**External Envelope:
Glass & Aluminium and
Stone Façade Elements**

CADENZA METROLINK INTERFACE

Credenza, Earlsfort Terrace, Dublin

**Document No:
1087-BDA-XX-ZZ-RP-Y-0001-C01**

Figure 10 Plan of Cadenza with TII predicted ground settlement

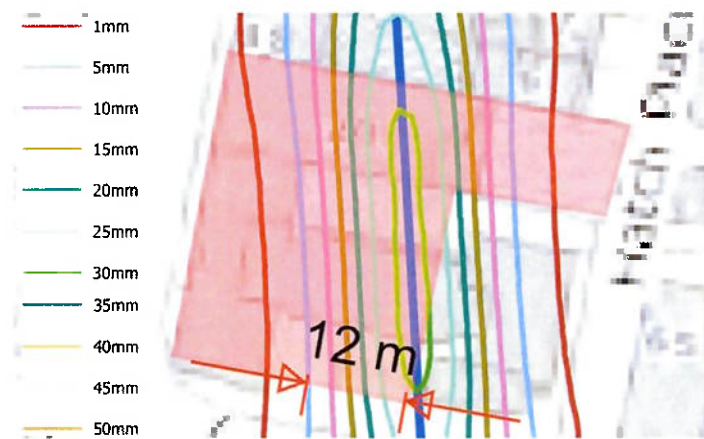
TII Reference: Submission Number 129. Irish Life Assurance Submission 1, Page 3, and TII response. We refer to TII's document EIAR Appendix 5.17 Building Damage Report page 126 of 158 indicating significant differential settlement across the site of the Cadenza Building.

MetroLink has assessed the predicted "Settlement" and presents its findings on drawing no. ML1-JAI- EIA-ROUT-XX-DR-Y-21146 rev P02. This drawing indicates MetroLink will be causing a 30mm settlement directly under the location of our client's building which is unacceptable. Settlements of this magnitude cannot be accommodated by the building's facades. Such settlement, particularly if introducing differential settlement between columns, will cause damage.

Figure 12 EWS-001 glass rotating due to differential settlement of one column (South elevation)

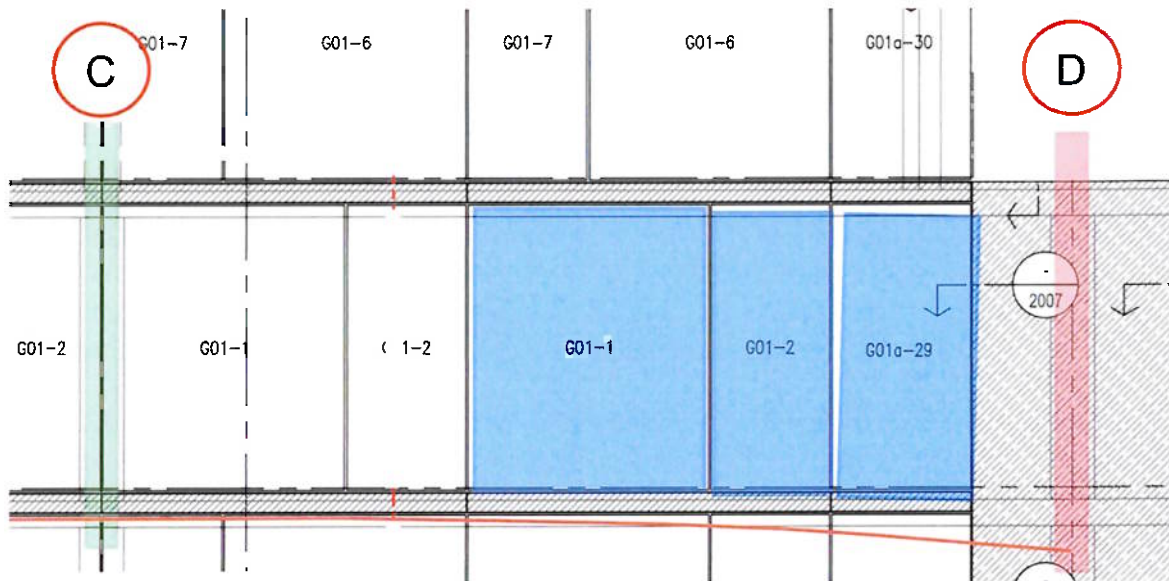
The vertical joint between double-glazed panels consists of 28mm silicone pointing with a 25mm PVC drainage tube. The silicone pointing can take small amounts of compression and tension. The PVC tube can accommodate small amounts of compression. If one column settles differentially, the glass panels either side of that column will rotate in plane compressing the silicone seal.

Due to the aspect ratio of the panels closest to gridline D on the South elevation, the TII predicted differential settlement of 25mm from Gridline C to D would result in 1.75m wide panels rotating in plane not less than 3.6mm at their base. As each panel is 3.5m tall this translates into 7mm rotation at the top corner of the panel. Such rotation would exceed the design parameters of the structural sealant at the glass to glass joint crushing and tearing the sealant and inducing stress in the glass. It may not cause breakage but will apply long-term stress into the structural sealant joint which may cause failure of the structural connection.

Figure 17 EWS-002 partial South elevation. Differential settlement of structure at Gridline D

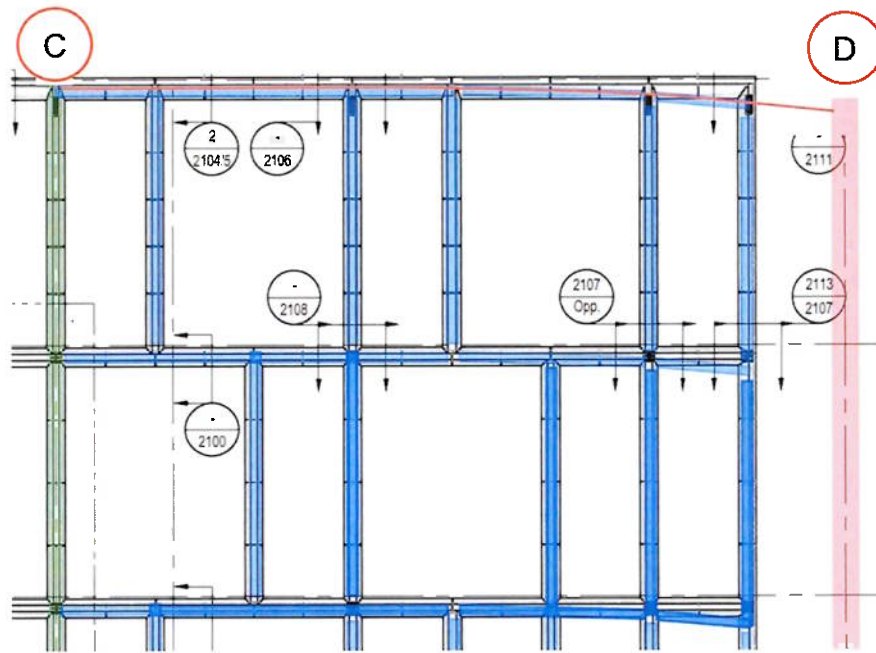
The diagram below looks to illustrate the effects of differential settlement of the column at Gridline D. As the Level 5 slab deflects, the veil goes out of square.

The differential settlement of a column causes rotation of the connection between horizontal and vertical veil elements. These connections are typically formed with countersunk fixings tapped into a block of stainless steel. These connections were not designed to accommodate significant rotation. Detailed analysis would be required to determine how these connections react and whether the horizontal beams of the veil would rotate at these connections or be forced to go into bending ('S' shaped bend on elevation). If over-stressed the connections could fail.

If the horizontal beams or vertical mullions go into bending due to differential settlement, this could cause over-stressing of the fixings in the stone exceeding permissible safety factors and/or causing cracking of the stone.

Figure 19 EWS-003 South elevation, Deformation due to ground settlement

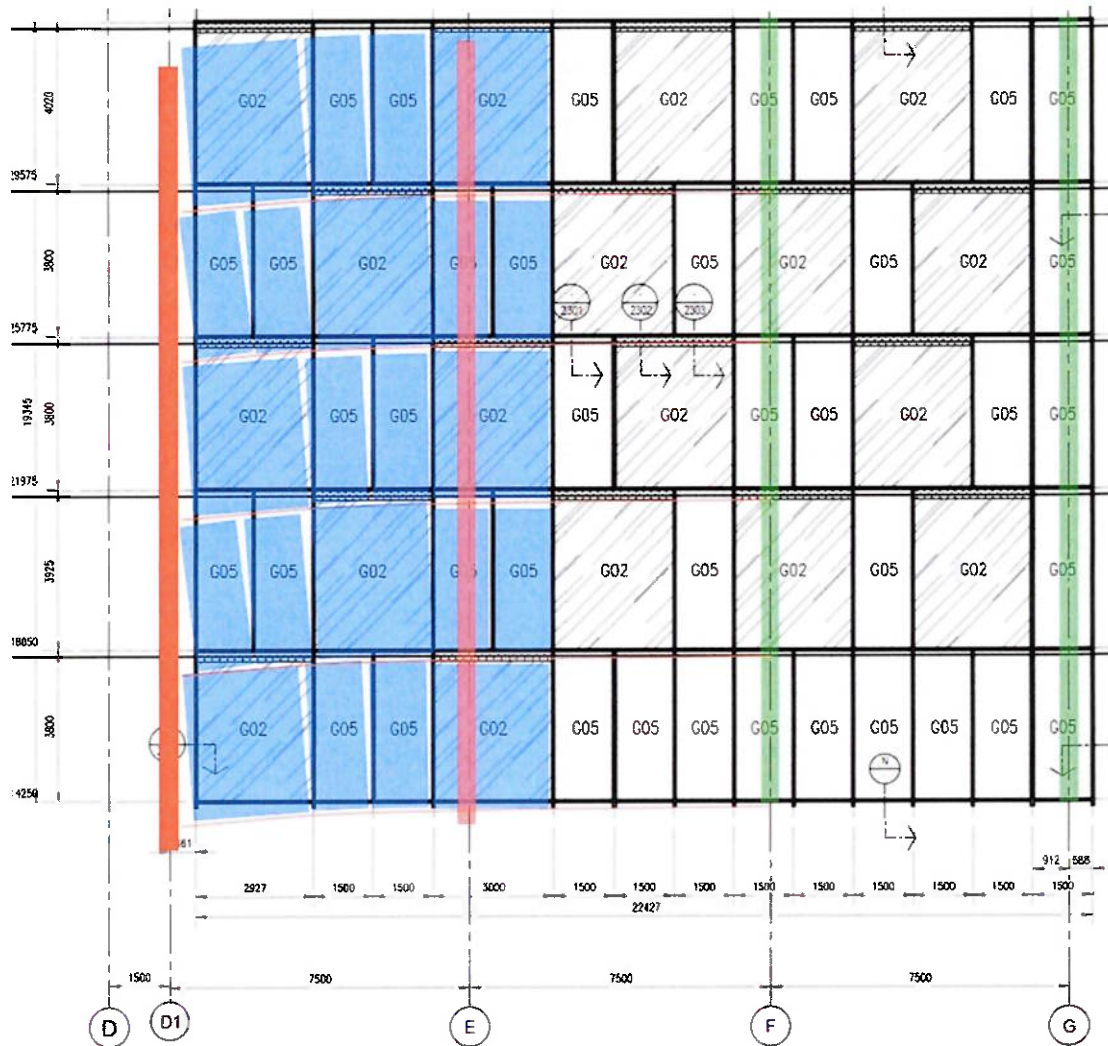
According to the TII's document EIAR Appendix 5.17 Building Damage Report page 126 of 158 the South elevation of EWS-003 will suffer differential settlement of 30mm from one side of the screen to the other.

The curtain wall system has very little capacity for racking of the glass on elevation. When the structure moves differentially as per the diagram above, the mullions remain vertical and the transoms rotate in plane. As each glass unit sits on a transom, the glass rotates with the transom. Based on the TII diagram there is approximately 30mm of differential settlement across quite a small width of approximately 10m.

Due to the aspect ratio of the panels closest to gridline D1 on the South elevation, the TII predicted differential settlement of 30mm in this area would result in 1.5m wide panels rotating in plane not less than 4.5mm at their base. As each panel is 3.8m tall this translates into 11mm rotation at the top corner of the panel. The toggle glazed system does not have capacity for this degree of movement. The mullion detail below shows the proximity of glass to metal. If the glass

Figure 20 EWS-003 Plan section of glass to mullion interface.

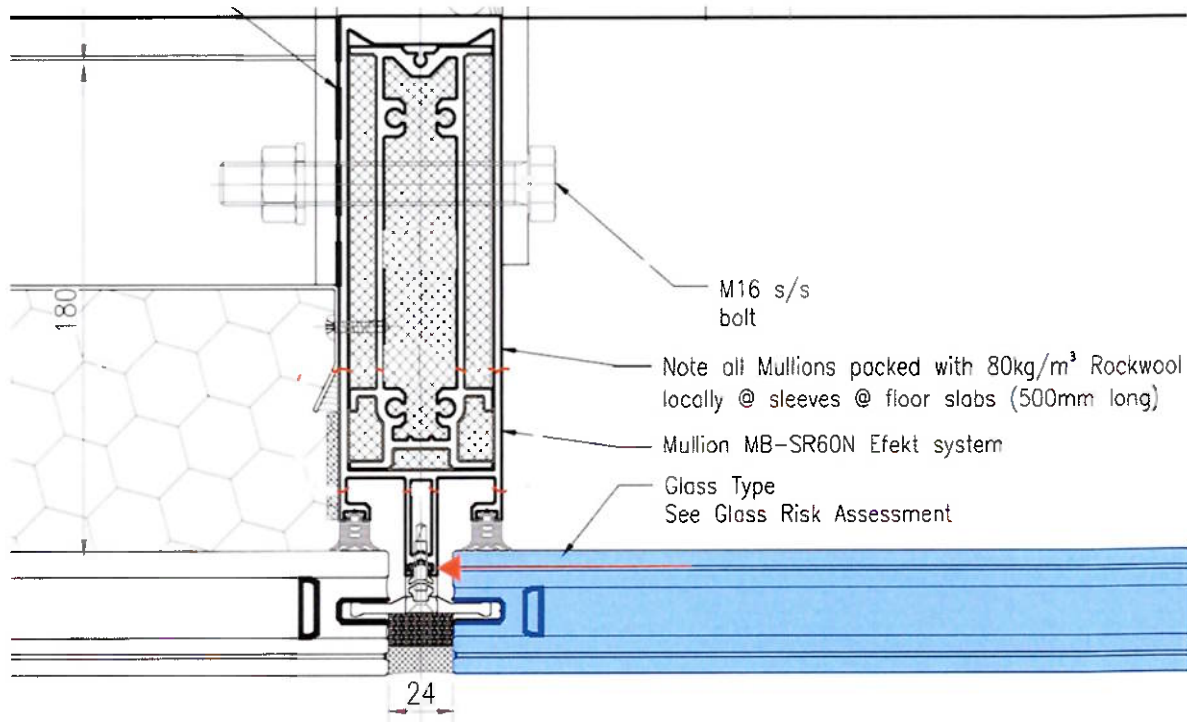
rotates too far, the inner glass impacts the aluminium mullion profile. The design gap, excluding glass tolerances and installation tolerances would be less than 6mm.

Figure 26 EWS-006 Head restraint detail.

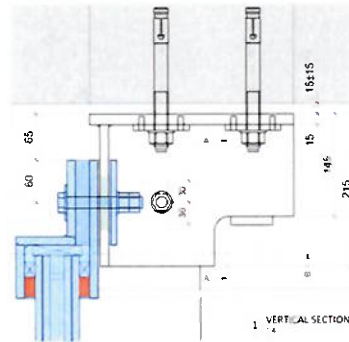
The double-glazed panels are restrained to only move vertically when the slab deflects. This lateral restraint is provided by a factory applied curved angle assembly structural silicone bonded to the glass (structural silicone shown red in the diagram below) at the head of each unit. This in turn engages with a local bracket fixed to the soffit of the slab above. The bracket has vertical slots are shown in green below allowing for deflection of the L01 slab while restraining movement along the screen (in and out of the page in this diagram).

Should settlement due to MetroLink works cause the Level G slab deflect more than anticipated in the current design, it is possible the permissible long-term shear load in the structural silicone at the head detail will be exceeded. If the head restraint were to fail, allowing the panel of glass to rotate in plane (along the elevation), there is a high risk of glass breakage due to metal to glass contact and/or glass to glass contact.

Figure 28 EWS-600 Plan detail of glass to glass joint with steel fin

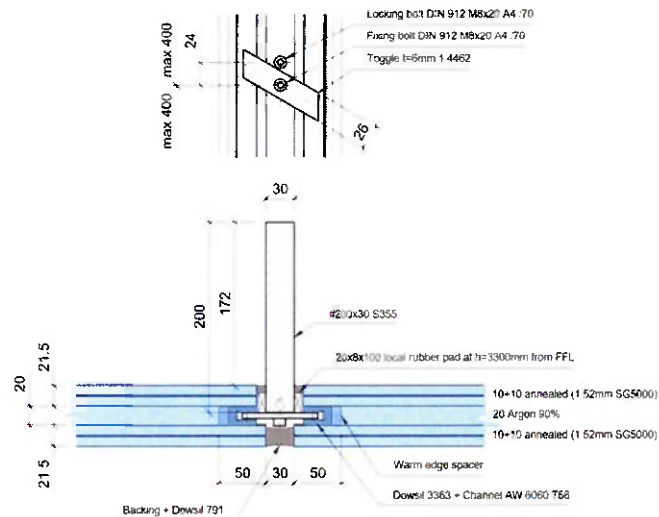
The glazing system has vertical fins between each double glazed unit. The fin is intended to provide resistance to wind load but has limited capacity to resist lateral in-plane loads. As can be seen in the diagram below, should the glass restraint at the head fail and the glass rotate in plane, there is a high risk the perimeter internal silicone seal would be crushed resulting in glass to metal contact.
